**THE UNIVERSITY OF SYDNEY
SERVICES BUILDING G12
22 CODRINGTON STREET
DARLINGTON NSW 2008**

Reference: **ACCESS REPORT**

**DARLINGTON ROAD TERRACES MIXED USE BUILDING ADDITIONS AND
ALTERATIONS TO THE DARLINGTON ROAD TERRACES AND PUBLIC DOMAIN
IMPROVEMENTS
STUDENT ACCOMMODATION PROJECT – REVISED SCHEME**

Revision [D]

Figure 3 Location of on street parking (blue zone indicates location of accessible parking space)

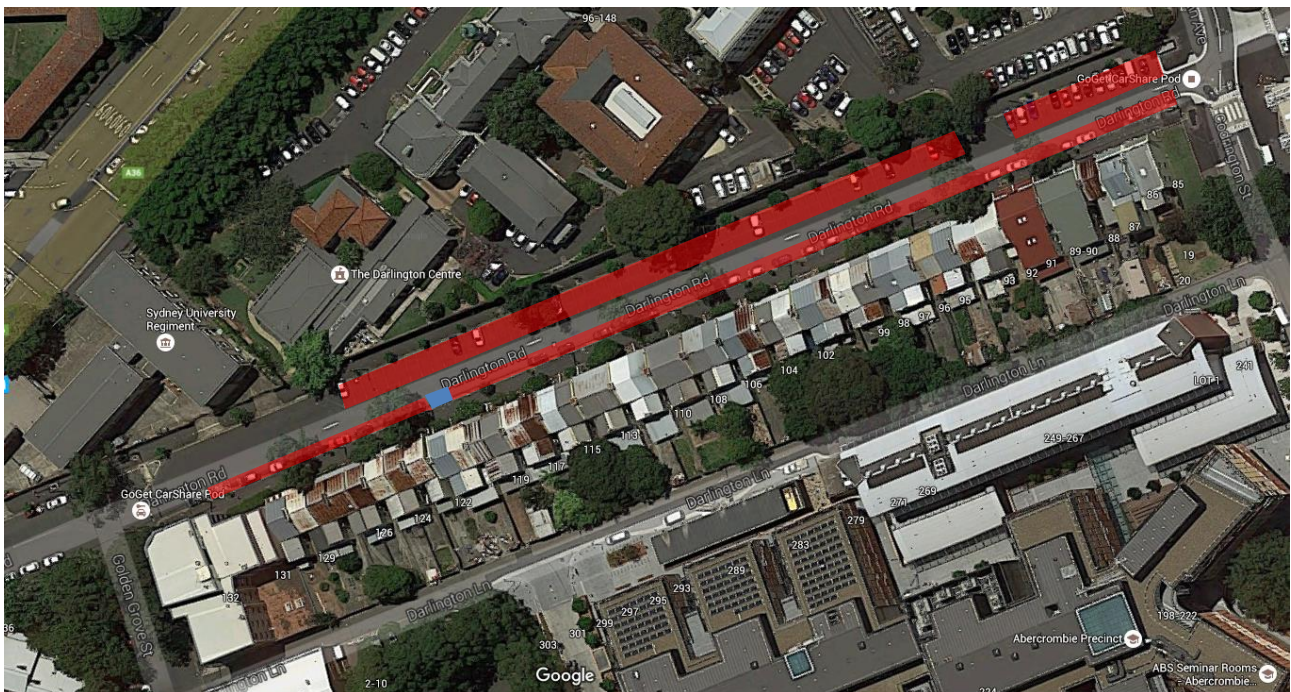
An on street accessible parking space is presently provided outside 121 Darlington Road. The sizing of the accessible parking space does not satisfy the requirements of A2890.6:2009.

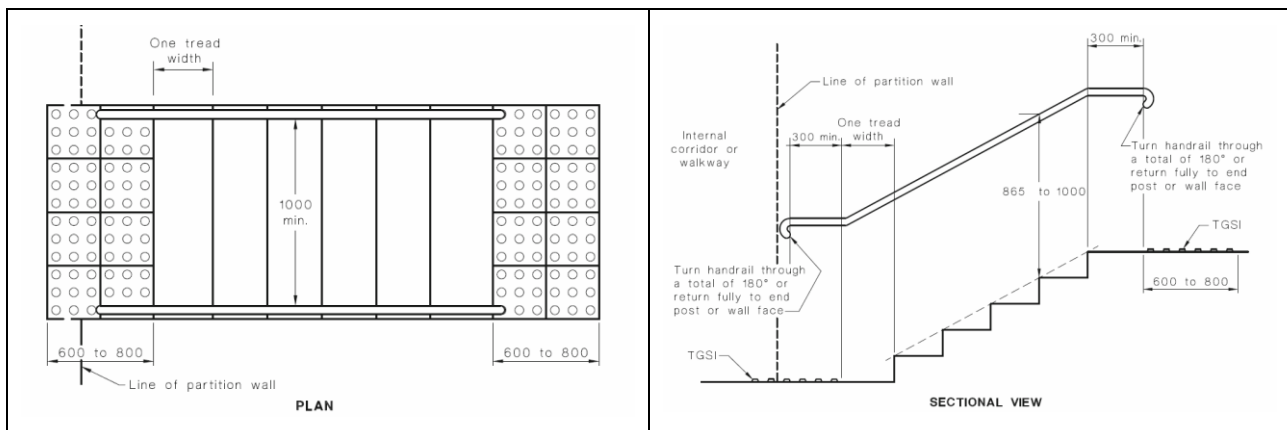
This courtyard is accessed from the Level 2 kitchen dining area of Building B and the Level 2 common area of Building C.

The central courtyard is also accessed from the rear of the terrace located at the rear of 102 Darlington Road. Access from the terrace to the central courtyard is provided by way of a stair and accessible access is provided by way of an AS1735.14 low rise platform lift to address the 840mm change in level.

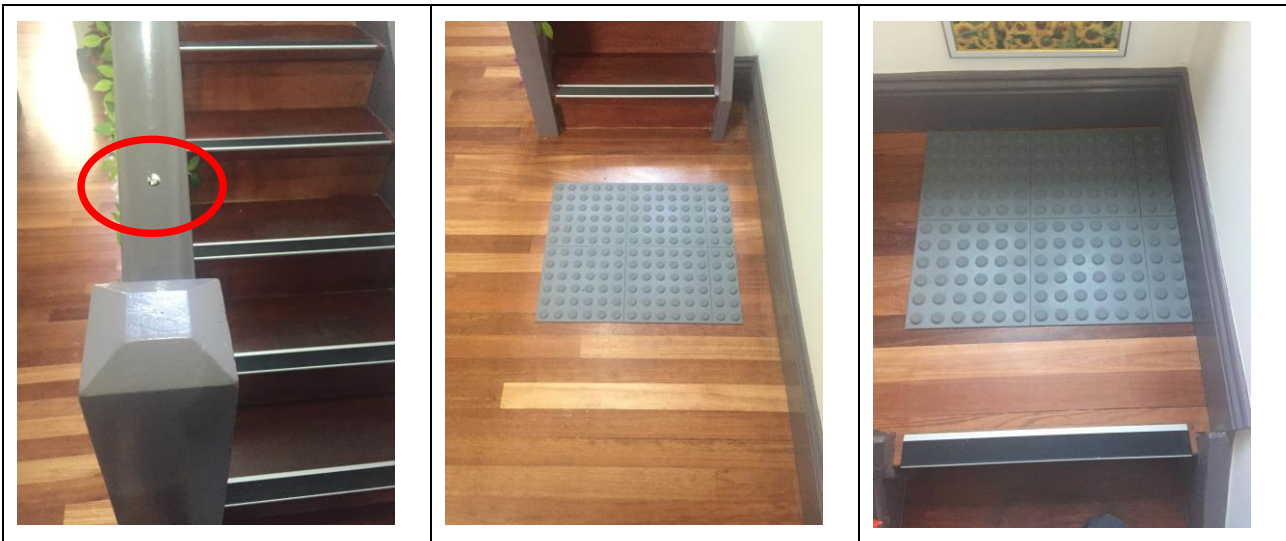
- Non-slip finish to each going
- Non-slip nosing fixed to each going
- A dome head screw fixed a minimum of 150mm from the top and bottom of each flight
- A minimum lighting level of 150lx
- TGSIs installed at the top and bottom of each flight (Not required at mid-levels where no additional population is added to the stair system)

The photos following provide an indication of this approach to the detailing of the existing balustrades and stairs within the heritage terrace houses.

Figure 4 image of non-compliant lift call button installation

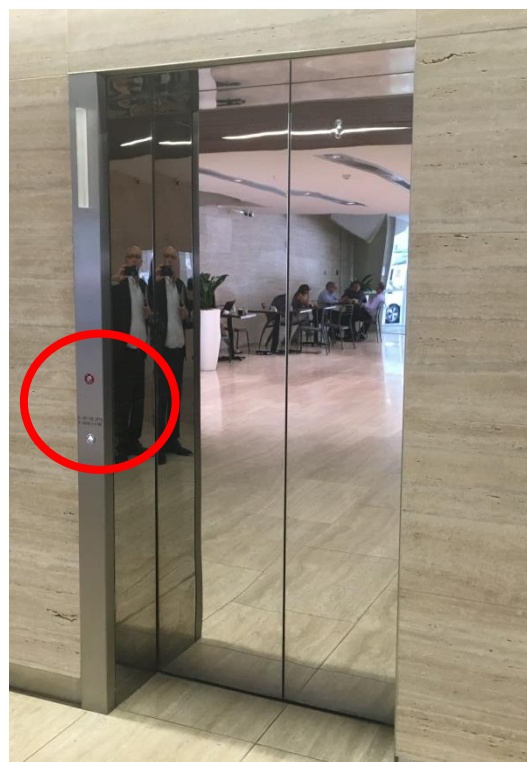
Attention is directed to the placement of the lift call button at each level. Many lift suppliers are locating the call button for single lift car installations in the jamb of the lift door assembly. If this surface is not flush with the adjoining wall the position of the button is not complainant with the provisions of Clause 13 of AS1428.1.
